Driver or Passenger Seat Module  
(DSM/PSM) Lid – Damaged or Loose –  
Lids Available Separately

MODEL 2001 MY-ON  
XK Range  
VIN A11051-ON

ILLUSTRATION 1

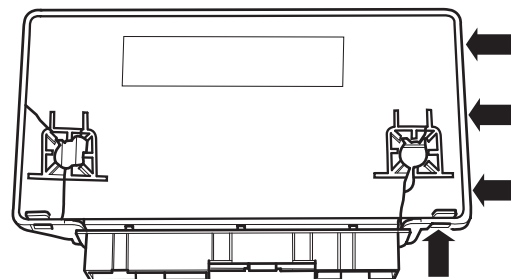
3. Use a suitable tool to carefully release the module lid tabs and remove the lid from the module. Retrieve any broken pieces from the old module lid (Illustration 1).

ILLUSTRATION 2

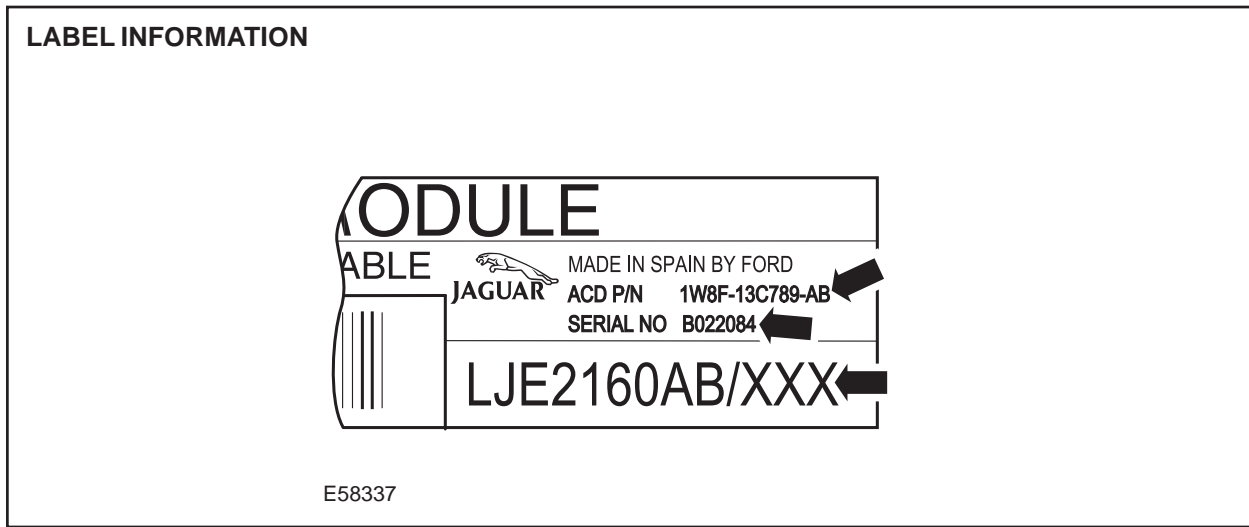
- Use a suitable permanent marker pen to transfer the information shown in Illustration 2 from the old module lid to the inside and outside of the new module lid).
